OPERATING CODE NO. 5
(OC5)

TESTING AND MONITORING

DRAFT

Figure 1: Frequency Response Capability Tests

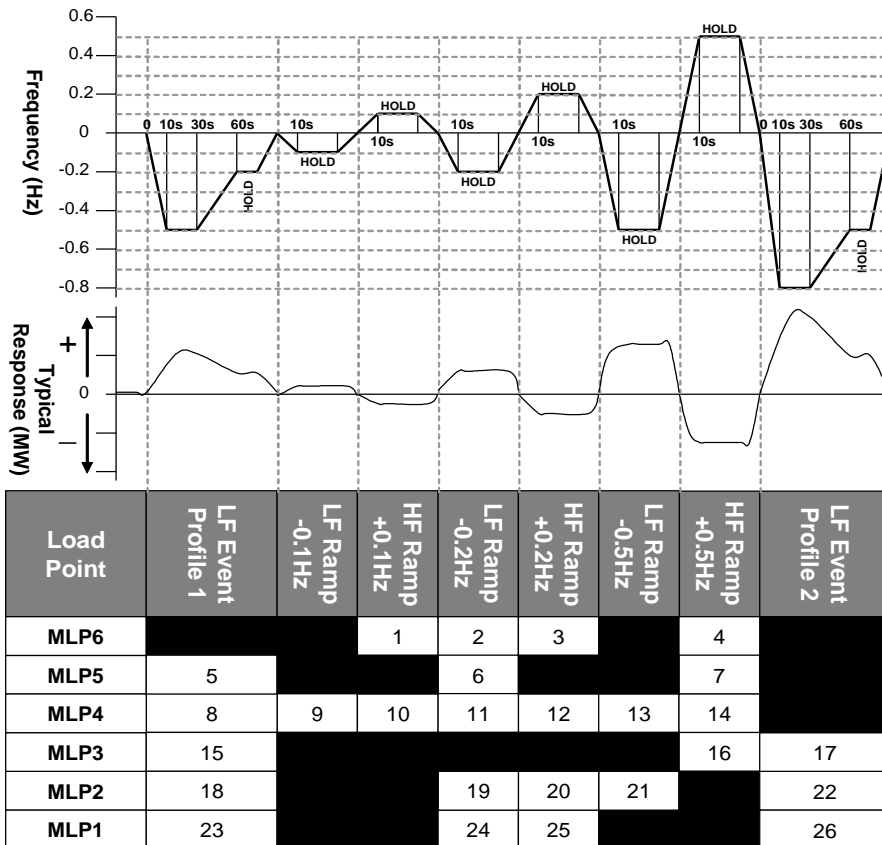
OC5.A.2.8.8 There should be sufficient time allowed between tests for control systems to reach steady state. Where the diagram states 'HOLD' the current injection should be maintained until the **Active Power** (MW) output of the **Generating Unit or CCGT Module** has stabilised for 90s, which ever is the longer. The frequency response capability test (see Figure 1) injection signal shall be returned to zero at the same rate at which it was applied. **The Company** may require repeat tests should the tests give unexpected results. When witnessed by The Company each test should be carried out as a separate injection, when not witnessed by The Company there must be sufficient time allowed between tests for the Plant to have reached a stable steady state operating condition or 90s, whichever is the longer.

Commented [A2]: Added to ensure the hold period is long enough to demonstrate "Secondary Response" time frame.

OC5.A.2.8 Figure 3 – Target Frequency setting changes

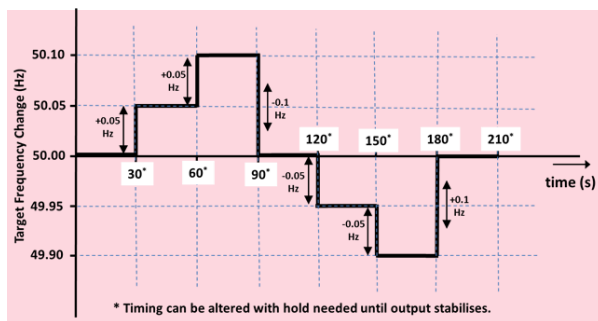
OC5.A.2.8.9 [The target frequency adjustment facility should be demonstrated from the normal **Control Point** within the range of 49.9Hz to 50.1Hz by step changes to the target frequency setpoint as indicated in ECP.A.5.8 Figure 3]

Commented [A3]: Added to demonstrate frequency set point changes and to be consistent with ECP

OC5.A.3.5 Figure 2 – Step injection sequence for voltage control tests

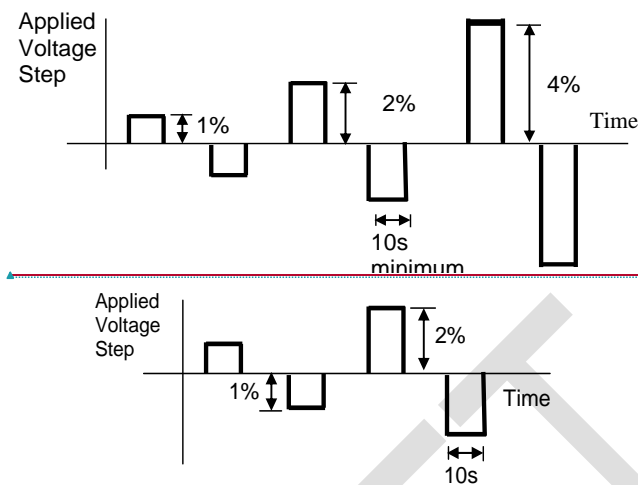
Commented [A8]: Change in response to SPR comment on ECP and to align with figure

Commented [A9]: Example added to highlight that the tests need to demonstrate that all elements of the reactive power solution are demonstrated during the test sequence

OC5.A.3.6. Figure 1 – Frequency response volume tests

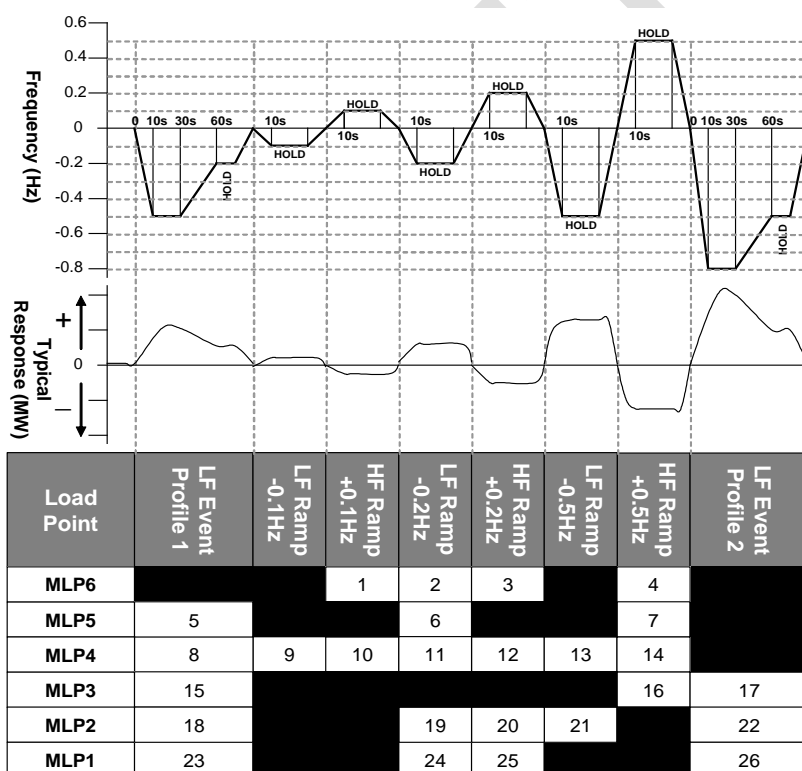
OC5.A.3.6.8 There should be sufficient time allowed between tests for control systems to reach steady state (depending on available power resource). Where the diagram states 'HOLD' the current injection should be maintained until the **Active Power (MW)** output of the **Power Park Module** has stabilised for 90s, whichever is the longer. All frequency response tests should be removed over the same timescale for which they were applied. **The Company** may require repeat tests should the response volume be affected by the available power, or if tests give unexpected results. When witnessed by The Company each test should be carried out as a separate injection, when not witnessed by The Company there must be sufficient time allowed between tests for the Active Power (MW) output of the Power Park Module to have stabilised or 90s, whichever is the longer.

Commented [A11]: Added to ensure the hold period is long enough to demonstrate "Secondary Response" time frame.

OC5.A.3.6. Figure 3 – Target Frequency setting changes

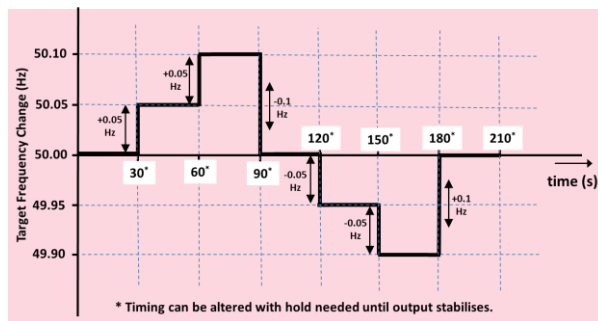
OC5.A.3.6.9 The **Target Frequency** adjustment facility should be demonstrated from the normal control point within the range of 49.9Hz to 50.1Hz by step changes to the **Target Frequency** setpoint

Commented [A12]: Added to demonstrate frequency set point changes and to be consistent with ECP

OC5.A.4.6. Figure 3 – Target Frequency setting changes

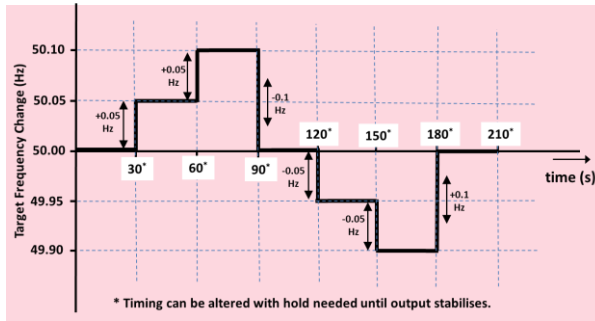
as indicated in OC5.A.4.6 Figure 3.

Commented [A16]: Added to demonstrate frequency set point changes and to be consistent with ECP
